Network Video Recorder

Version: V4.74.000 build230217

Release Note

Support using different colors to distinguish event /non-event video and human/vehicle video for Hik-Connect playback.1. Support using different colors to distinguish event video and non-event video for

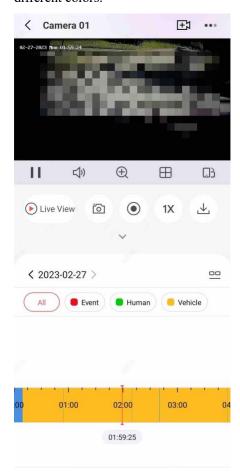
HC playback. Support quick filtering of human/vehicle video, and human/vehicle videos display in different colors.

Improve the PTZ control function

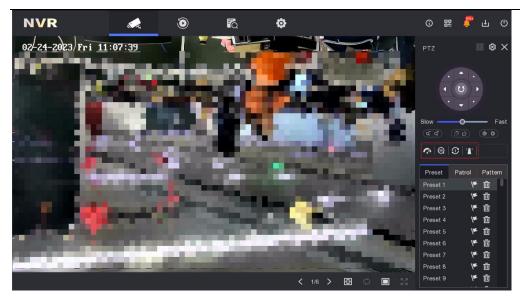
Support One-Touch Park, One-Touch Patrol, 3D Zoom, and wiper control functions in local EUI and web page.

Support configuration the Supplement Light Mode of IPC on Local EUI

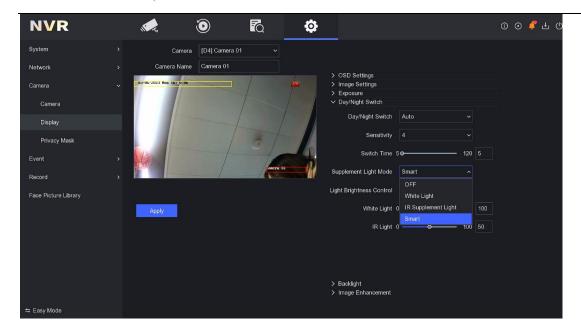
Support configuration the Supplement Light Mode of IPC on Local EUI.

Support the Schedule Reboot function

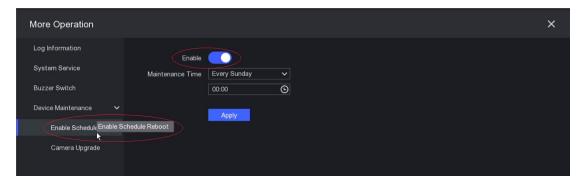
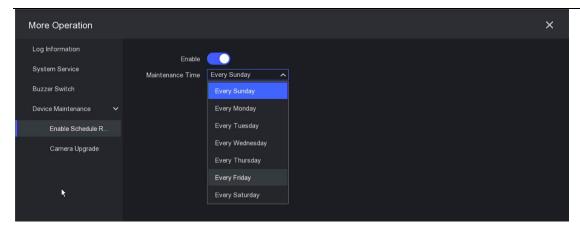
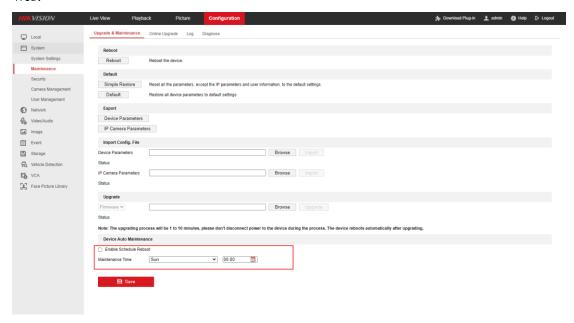
Support setting the Schedule Reboot function on the local EUI and web page, the NVR will reboot automatically at a certain time on a certain day every week. This function is disabled by default. Local EUI:

Support display the error code of Hik-Connect abnormal status on the web side

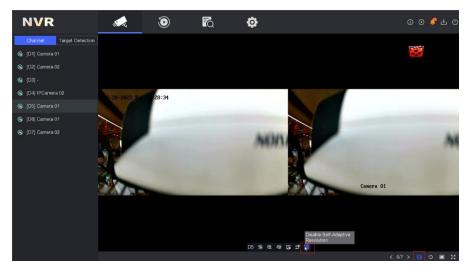
When the Hik-Connect status is abnormal, the error code will be displayed on the web side.

Support configuration Self-Adaptive Resolution on Live view and Playback

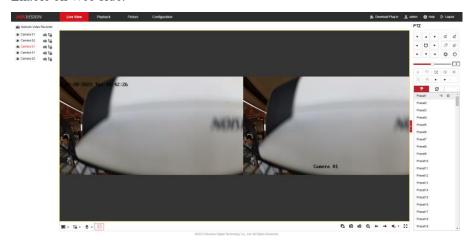
Support configuration Self-Adaptive Resolution on Live view and Playback, enable by default. Enable on Local EUI:
